Re: NYISO 2021-2025 ICAP Demand Curve Reset Process  
Comments on NYISO Staff Final Recommendations

**Comments of GenOn Bowline, LLC and GenOn Energy Management, LLC  
on NYISO Staff Final Recommendations for the 2021-2022 ICAP  
Demand Curves and the Parameters for the  
2021-2025 Demand Curve Reset Process**

### Ramapo IT Available Days vs Ramapo Interconnect Utilization

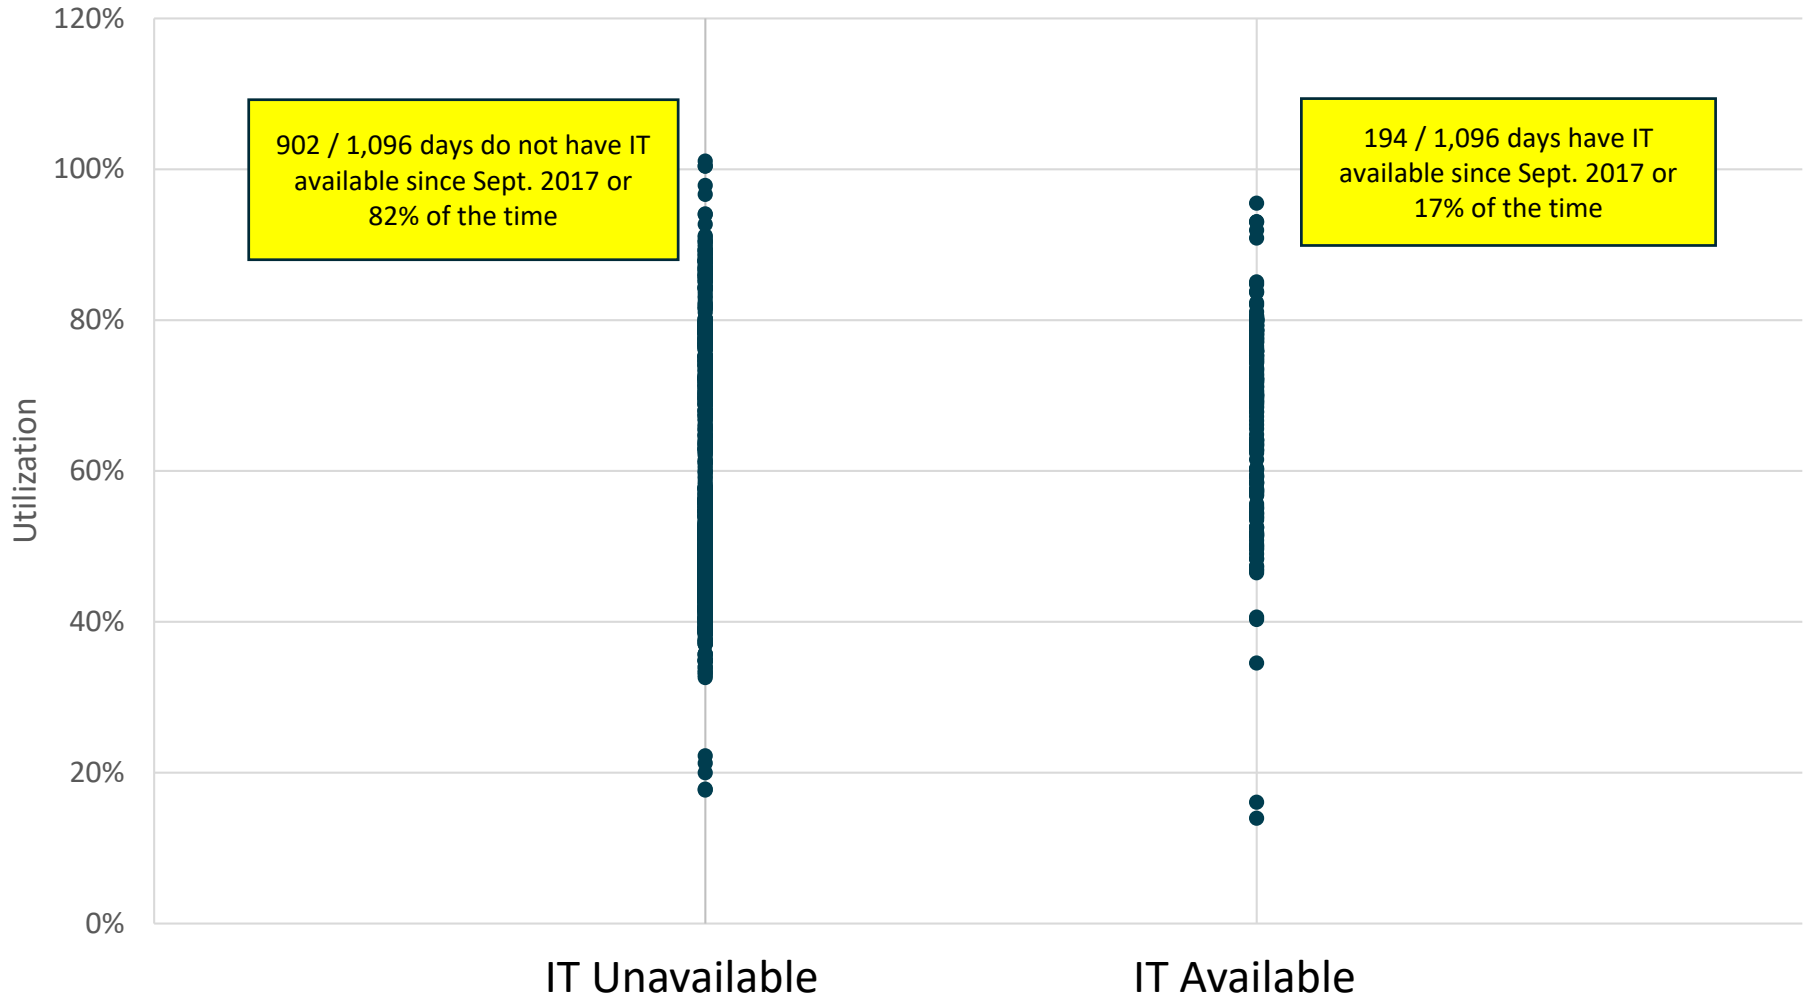
the pipeline's system is not being fully utilized).<sup>28</sup> For example, at the Ramapo Interconnect, interruptible transportation service has been unavailable more than three quarters of the time since September 2016, including on days where Ramapo compressor utilization was less than 20%.<sup>29</sup>

Utilization at Ramapo interconnect with Millennium vs days IT service available at same point shows that there is very little correlation between utilization and whether IT is available. Utilization not an accurate marker of whether peaking plant will be able to secure IT

## Monthly Average AGT Flows at Millennium Mainline by Nomination Cycle

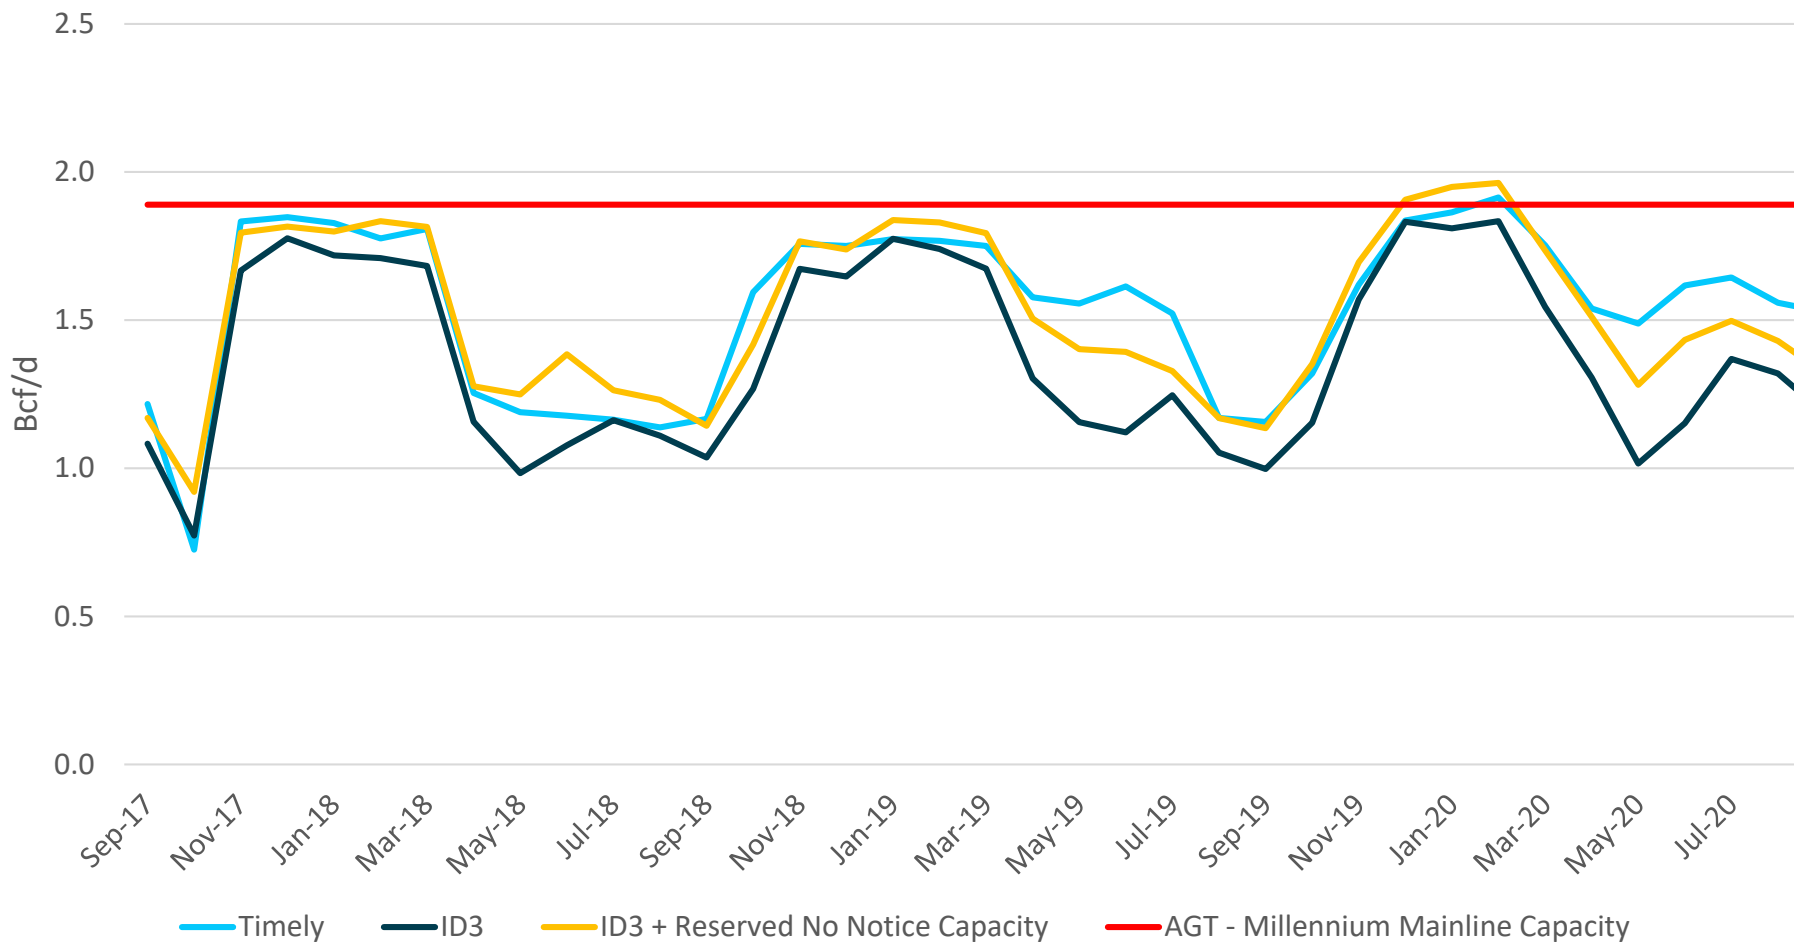
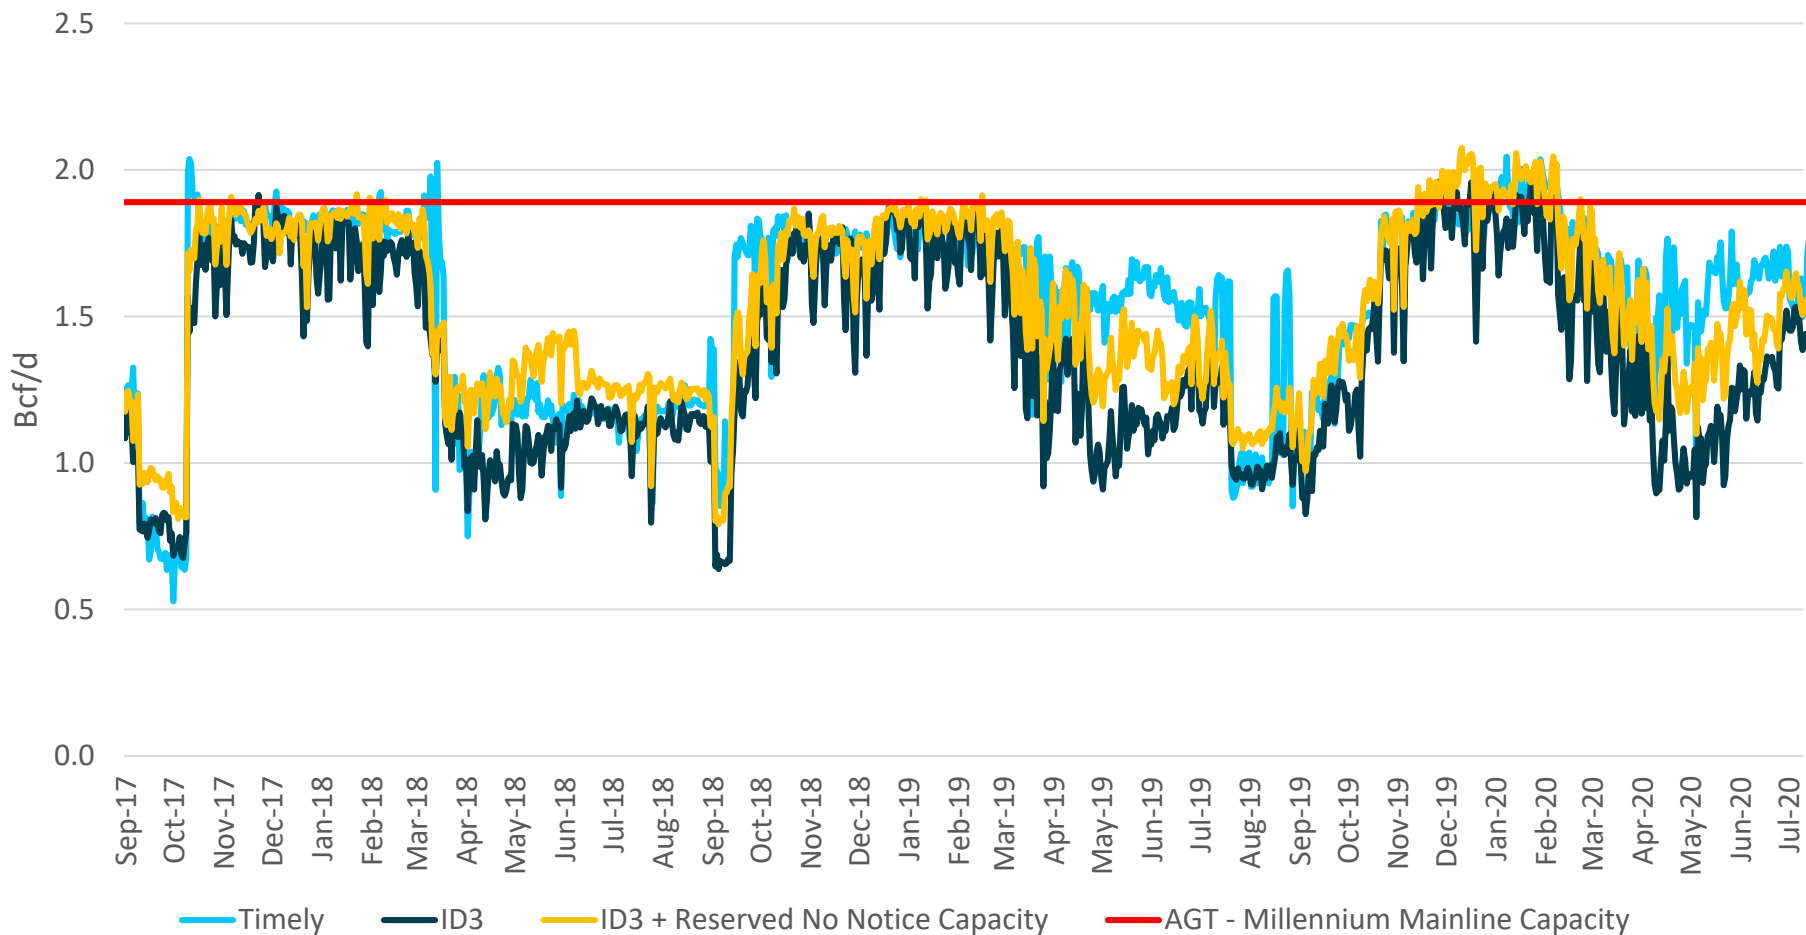
To identify whether interruptible transportation service was, in fact, available on any given day, the ID3 nominations, the reserved no notice service *and* the IT flag data sets must all be reviewed. As revealed in Attachments 2 and 3, analyzing the actual pipeline data is critical, particularly during the peak months given the proxy peaking plant's role as the reliability unit.<sup>34</sup> Because the MMU used data from just the first step in the gas scheduling process, it relied on an incomplete data set which led it to erroneously conclude that there was adequate interruptible transportation service available during most of the days in these months. The complete data sets, however, reveal there is actually very little to no available interruptible transportation service. Specifically, since the CPV Valley generating plant began operating in Zone G in the fall, 2018, interruptible transportation service on the Algonquin pipeline has essentially never been available.<sup>35</sup> For example, pipeline-generated IT flags confirm *no* interruptible transportation

Timely nominations are higher than ID3 (end of gas day) nominations as timely reflects expectations for the next day and shippers typically over-nominate. ID3 + no-notice service best reflects the day's actual flows as no-notice is typically withheld during nomination cycles. Looking at only timely or ID3 overestimates available pipe capacity for IT service as the pipeline must reserve no-notice capacity for contract shippers

## Daily Flows on AGT at Millennium Mainline by Nomination Cycle

### % of Available Capacity on Algonquin at Millennium Mainline for Peaking Plant using ID3 + No Notice

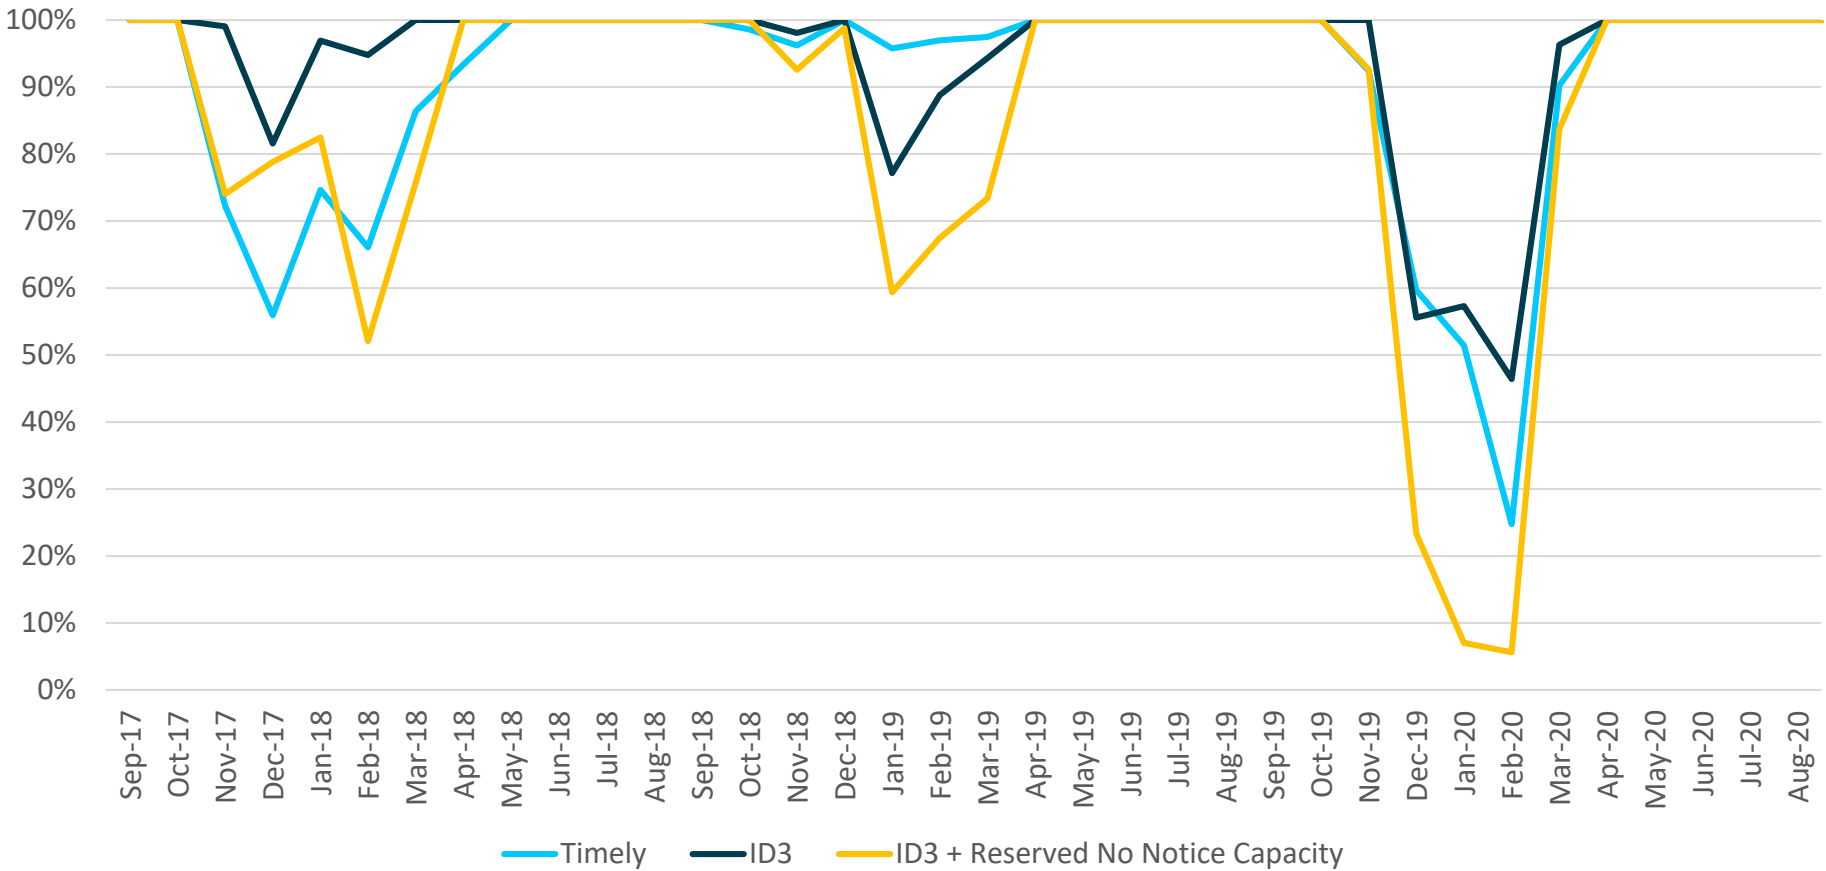
Using actual flows on Algonquin, adequate capacity for peaking plant is only available during the summer due to downstream no-notice service for LDCs, which take precedent over IT nominations. Actual flows on a pipe are best represented using ID3 nominations + capacity reserved for no notice service on the pipe. No-notice capacity reservations are not reflected in intraday nominations so must be added on to final nominations to show actual available capacity that could potentially be utilized for IT. Peaking plant would not have access to adequate capacity in Rockland County during the winter.
